RE: 447 Warburton Ave

Please see attached revised drawings for the above reference address. The changes include the following:

PROPOSED ALTERATION/ ADDITION

AT: 447 WARBURTON AVE. HASTINGS-ON-HUDSON, NY

A-2

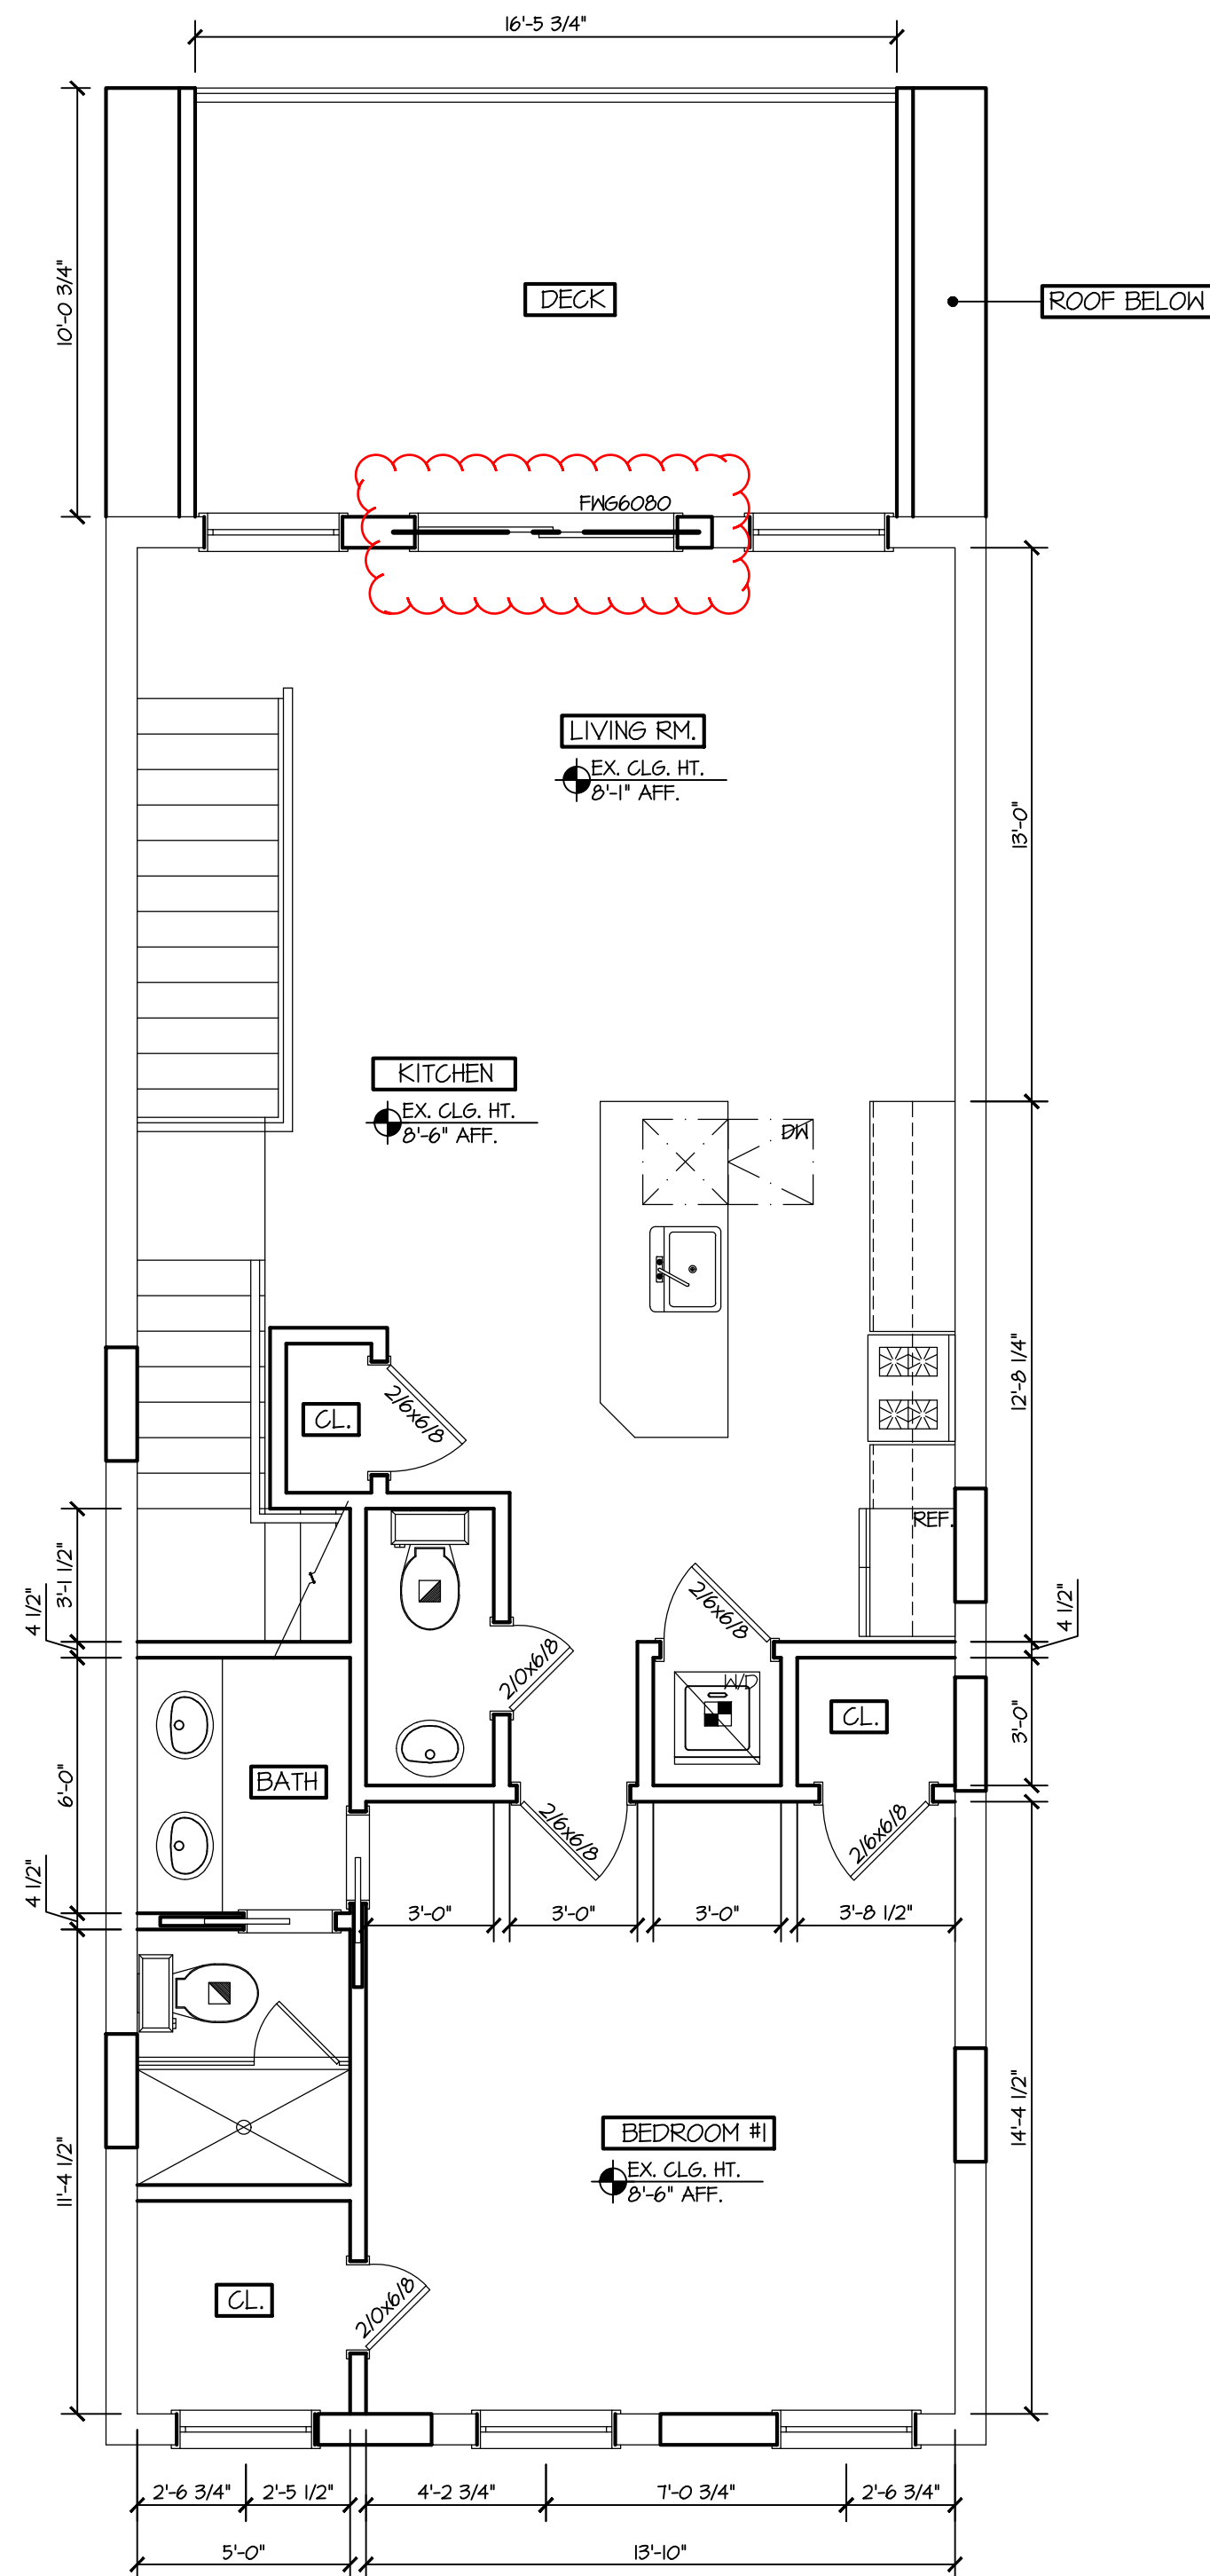
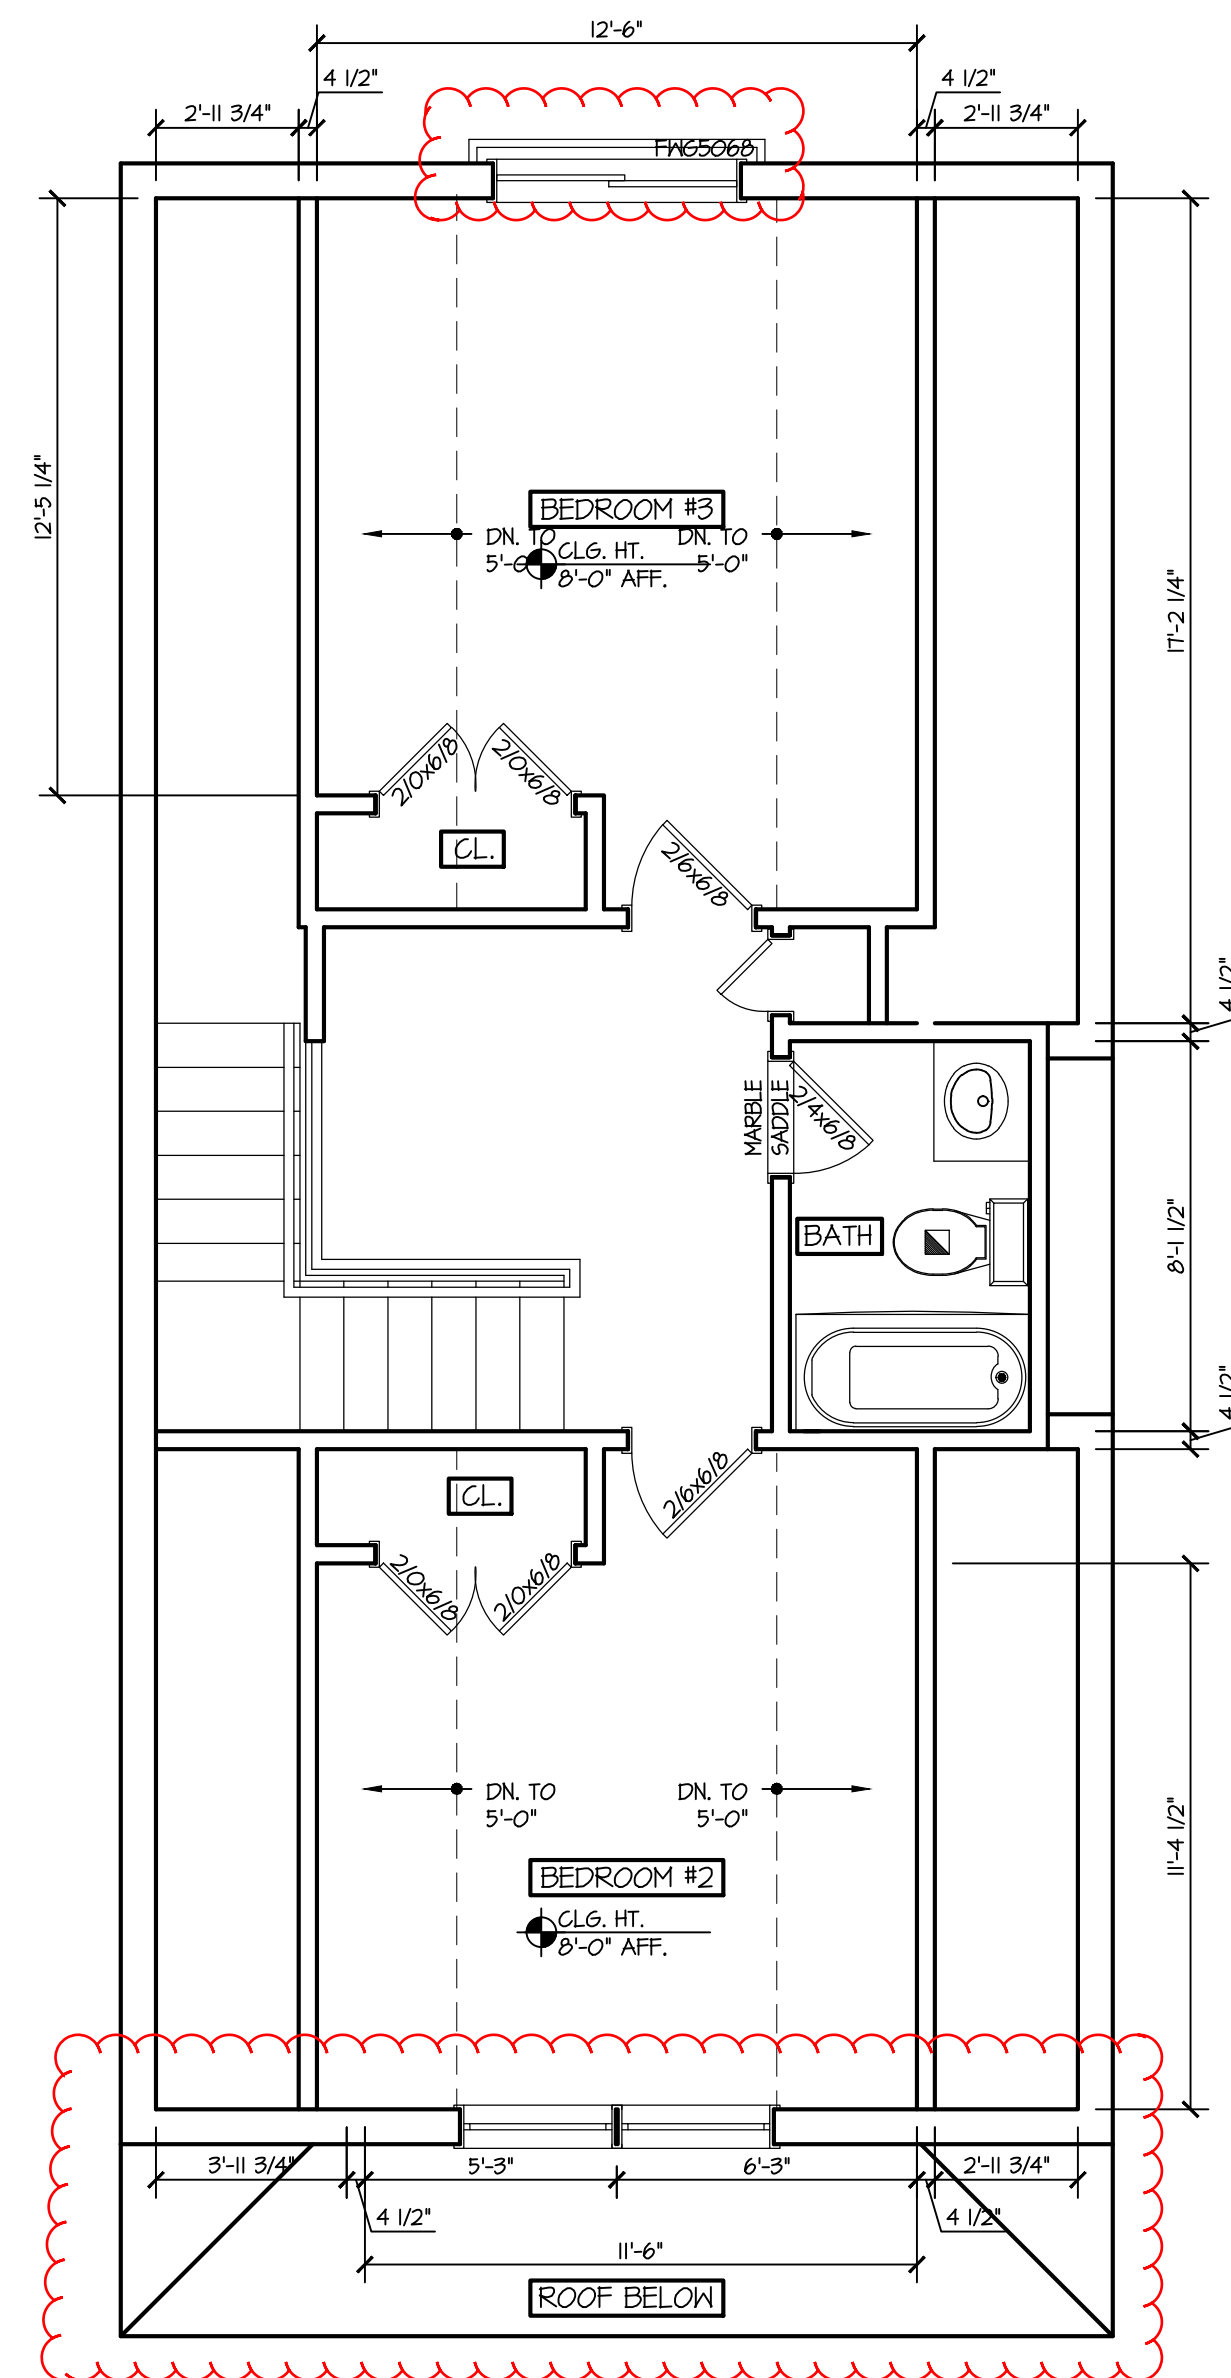
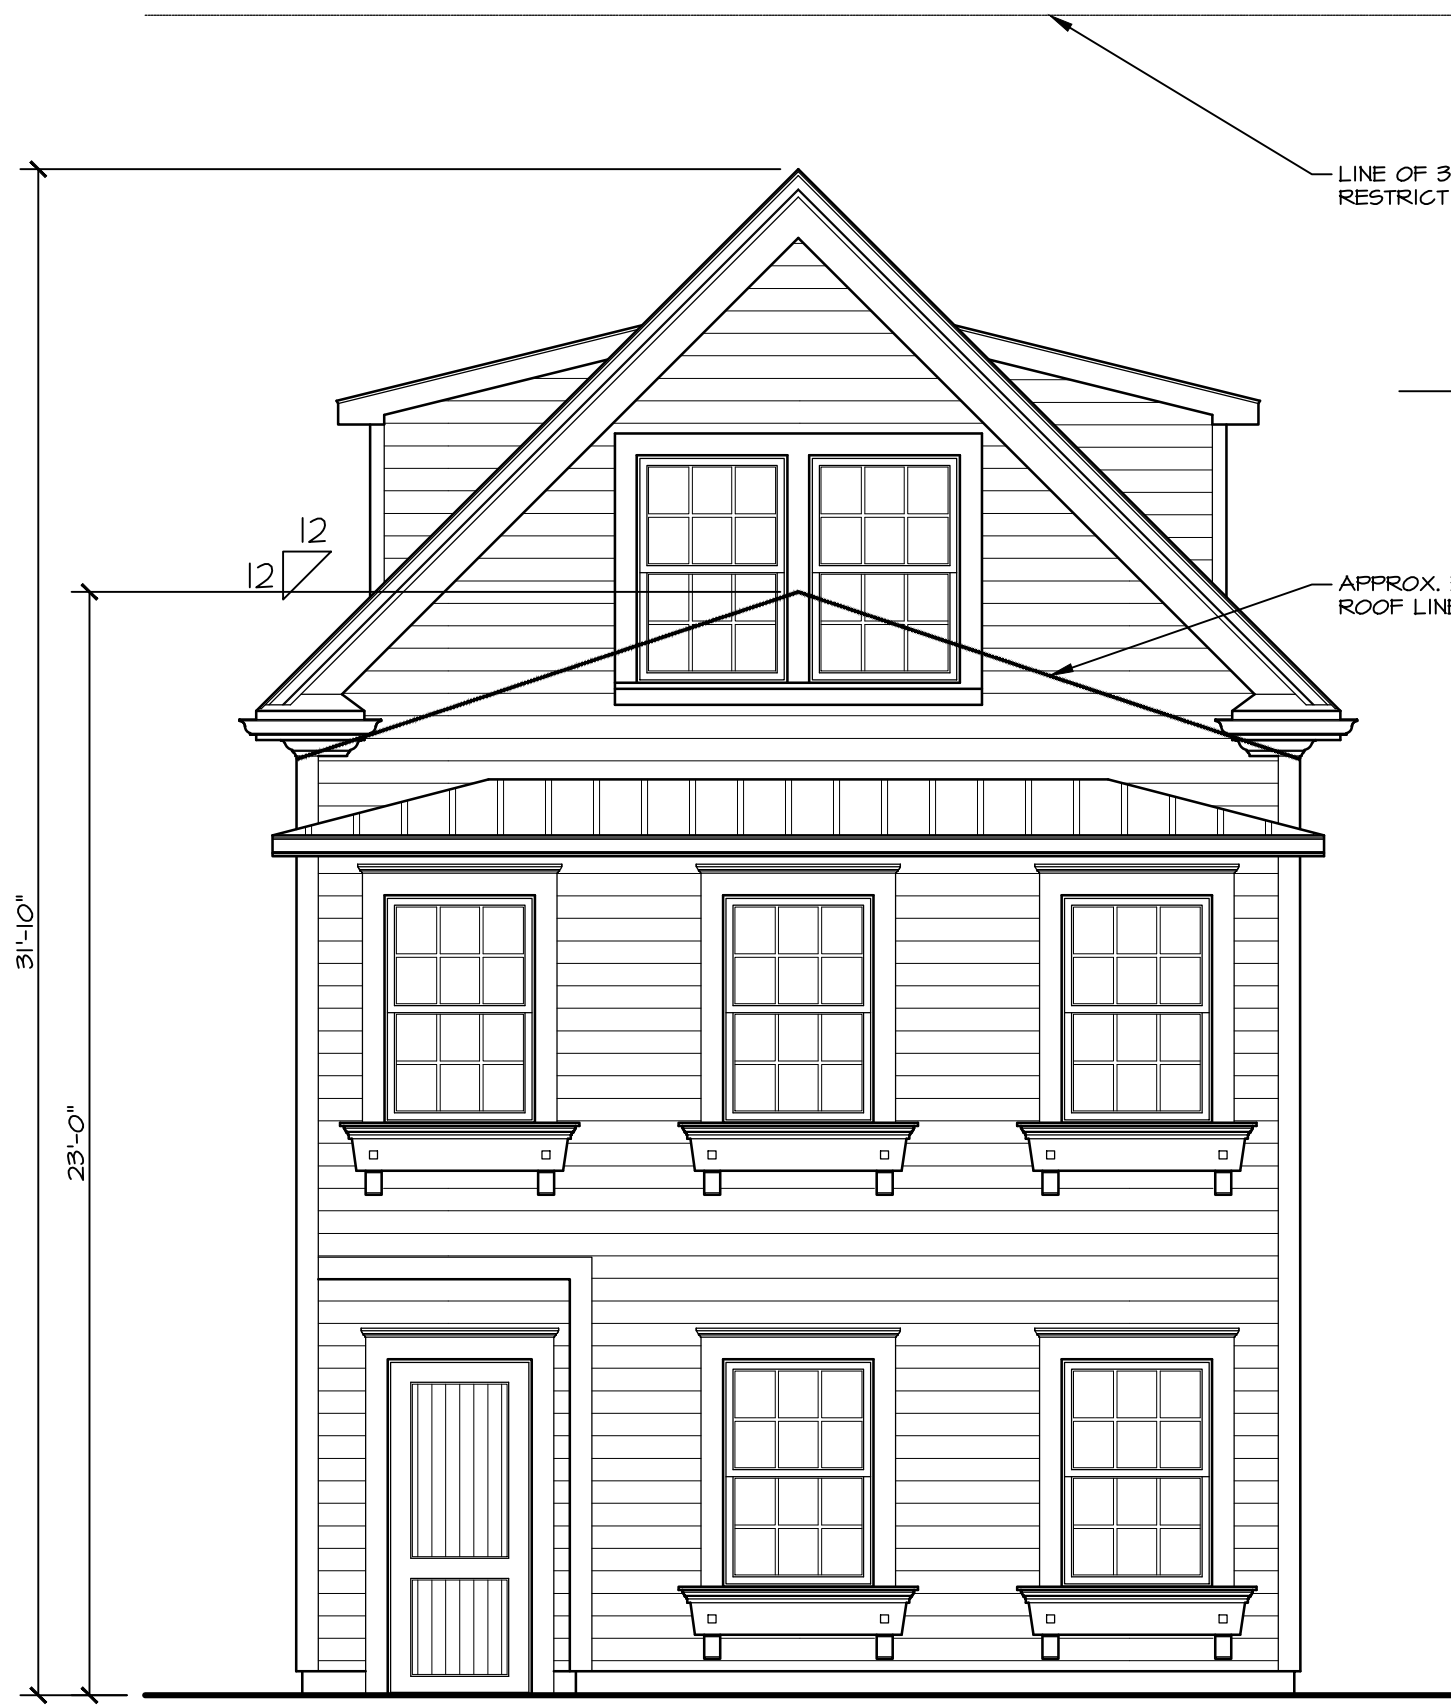
- 1.) The zoning chart has been revised because the deck now complies with the setback
- 2.) We have changed the size of the sliding doors at the rear of the dwelling on the first, second and third floor.
- 3.) The second-floor deck has been reduced and screen walls have been added.
- 4.) The third-floor front wall 4' back from the front setback.
- 5.) Third-floor knee wall has been reduced from 3'-0" to 1'-6"
- 6.) All elevations have been revised
- 7.) Dimensions have been added to ZA-5 sheet.
- 8.) Renderings have been revised and additional angles have been provided.
- 9.) Renderings from neighbor's residence have been added.
